SERVICE – BULLETIN

Reference-N°: KTSE - SB - 2207

Water Ingress into the Cabin

Model	Serial N°
KX027-4	→ 56162
KX030-4	→ 52196

**Step 14:**

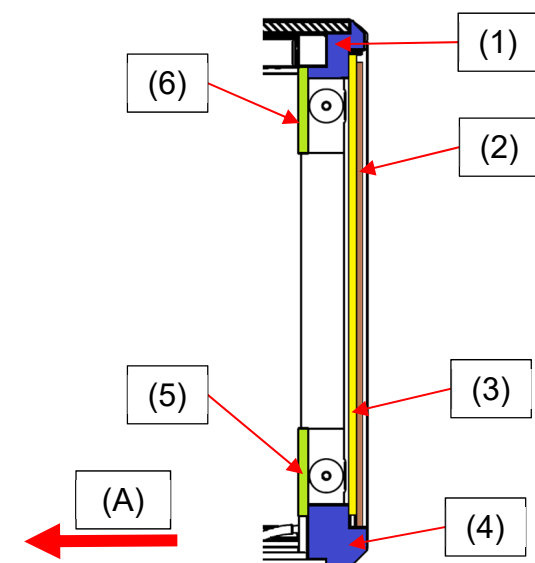
Remove the old rubber sealings (1), (2), (3), (4), (5), and (6).

Step 15:

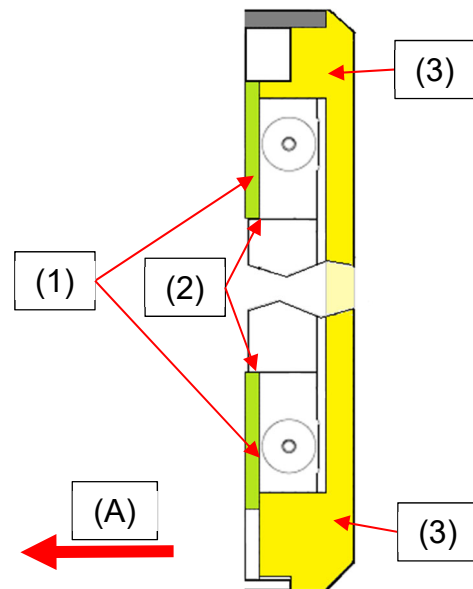
Attach the new sealing (1) (RG268-4969-0) to the cabin. The new seal must contact the remaining seal (2) on both sides and must be aligned to the edge of the cabin (3).

**Step 16:**

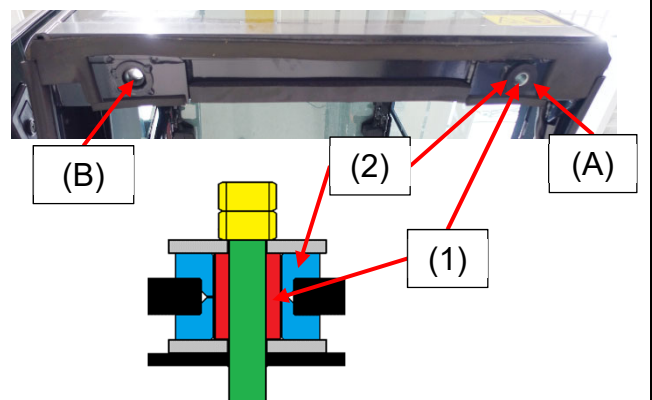
Attach the two new sealings (1) (RG268-4968-0) to the cabin. The sealings must be aligned to the edge (2) and must contact the sealing (3) (RG268-4969-0).
